Tennessee Valley Authority, Post Office Box 2000, Decatur, Alabama 35609-2000

BROWNS FERRY NUCLEAR PLANT (BFN) – UNITS 1, 2, AND 3 – TECHNICAL SPECIFICATIONS (TS) CHANGES TS-418 AND TS-431 – EXTENDED POWER UPRATE (EPU) – SUPPLEMENTAL RESPONSE TO ROUND 19 REQUEST FOR ADDITIONAL INFORMATION (RAI) AND RESPONSE TO ROUND 22 RAIs REGARDING STEAM DRYERS (TAC NOS. MD5262, MD5263, AND MD5264)

SUPPLEMENTAL RESPONSE TO ROUND 19 REQUEST FOR ADDITIONAL INFORMATION (RAI) AND RESPONSE TO ROUND 22 RAIs REGARDING STEAM DRYERS

Figure EMCB.158-1: BFN2 MSLs A & D Piping Layout

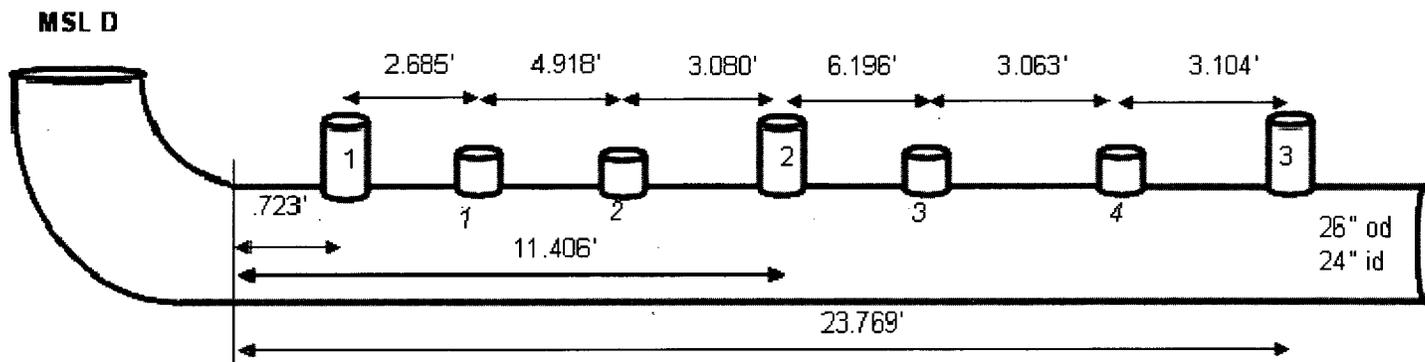
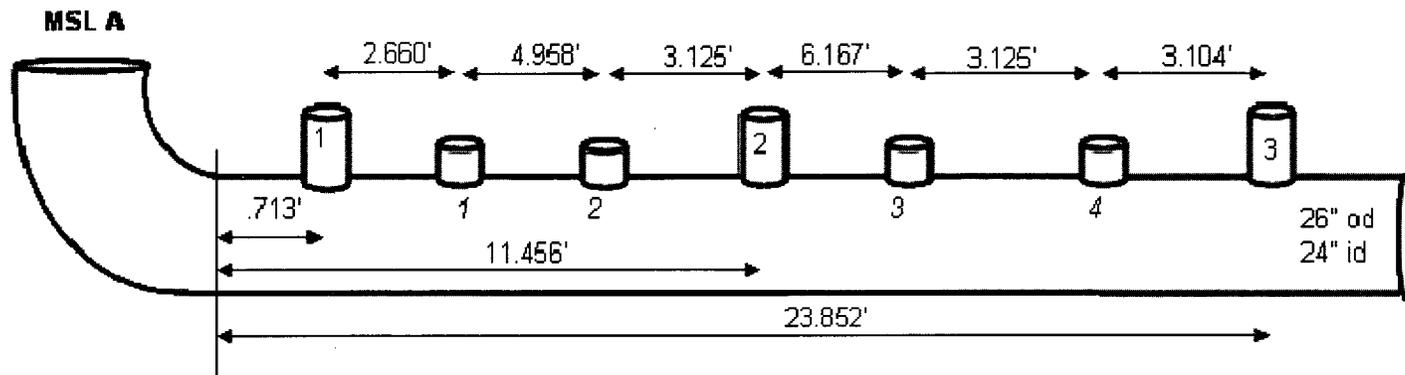
Provide the comparisons of the following data associated with MSLs 'A' and 'D':

- (1) piping layouts,
- (2) strain gage locations, and
- (3) locations and dimensions of SRVs.

The requested information for main steam lines (MSL) A and D is provided below. This information provides the similarity of the piping layouts for the two steam lines. The substitution of the LF signals for MSL D is based on the similarity of the signals as discussed in the response to RAI EMCB.159.

- (1) Piping layouts for MSLs A and D are provided in Figure EMCB.158-1.
- (2) Strain gage locations on Unit 2 are provided in Table EMCB.158-1.
- (3) The locations of the SRVs are depicted on Figure EMCB.158-1. SRV dimensions are provided on Figure EMCB.158-2.

Figure EMCB.159-1: BFN2 MSL A Upper and MSL D Upper Comparison

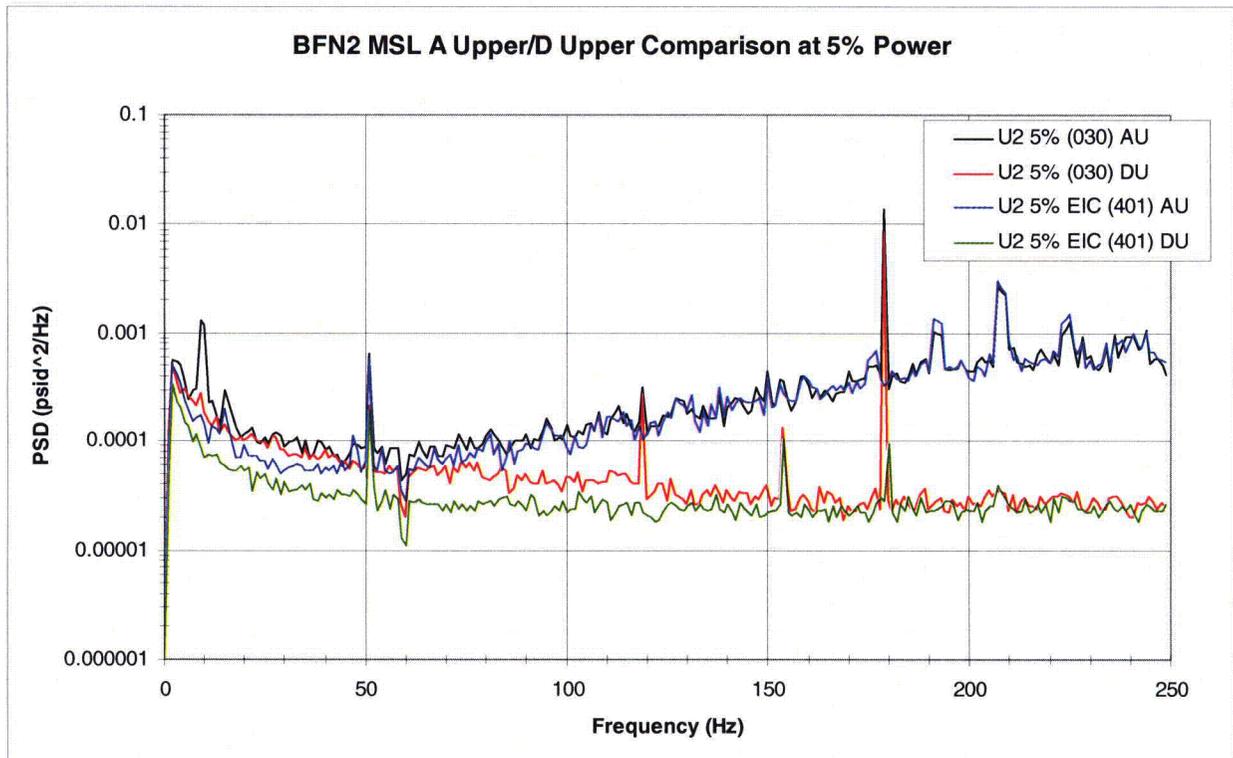
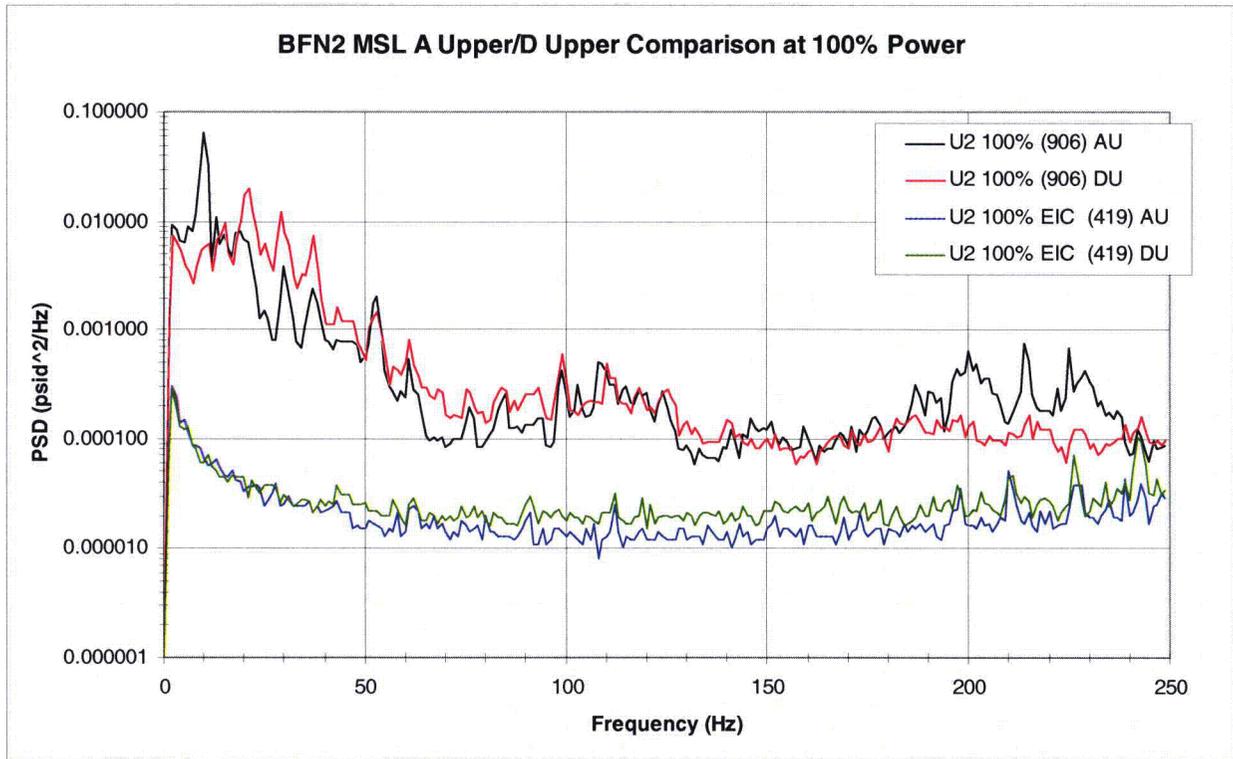
Demonstrate that (1) the filtered signals for MSL 'A' upper and MSL 'D' upper are similar for both the low flow (5 percent power) and CLTP-flow conditions for Unit 2, (2) the filtered signals for MSL 'A' lower and MSL 'D' lower are similar for the CLTP flow conditions, and (3) the bump-up factors for MSL 'A' lower and MSL 'D' lower are similar.

- (1) Figure EMC.B.159-1 provides the power spectral density (PSD) plots for MSL A Upper and MSL D Upper at CLTP and LF conditions with their companion EICs. For substitution, the LF MSL A Upper signal is scaled based on the LF MSL D Upper signal. This reduces the substituted signal in the frequency ranges where the MSL A Upper signal is greater than the MSL D Upper signal. Reducing the LF substituted signal provides a conservative signal to be removed from the CLTP signal.
